DATE: 20/03/2018

MODEL: ALL

FIRE EXTINGUISHER NOZZLE BRACKET***PRIORITY – HIGH (ACTION)***

Figure 1 – Nozzle Mounting

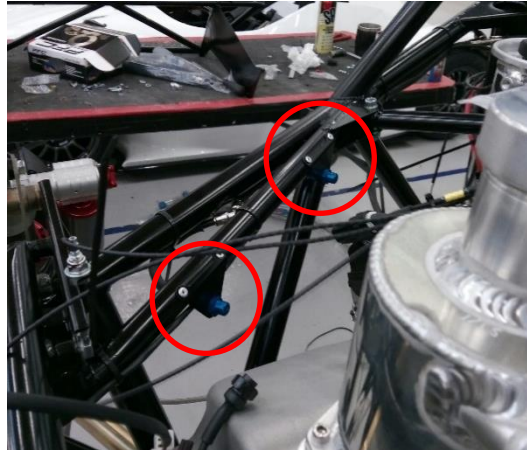
In line with extinguisher manufacturer recommendations and homologations, fire extinguisher nozzles in the engine bay must be rigidly mounted at the nozzle.

In order to facilitate this on existing cars, Radical has designed a securing bracket that can be riveted into the chassis as shown in the above photo.

If required from the factory, the part number for the bracket is AF0040. To secure this, two 4mm rivets are required per bracket, with 4 brackets needed per car. Additionally, 4 nuts may be required that fit on the back of the nozzle, part number AF0042.

The production fitment for these brackets will be 2" in from the ends of the tube.
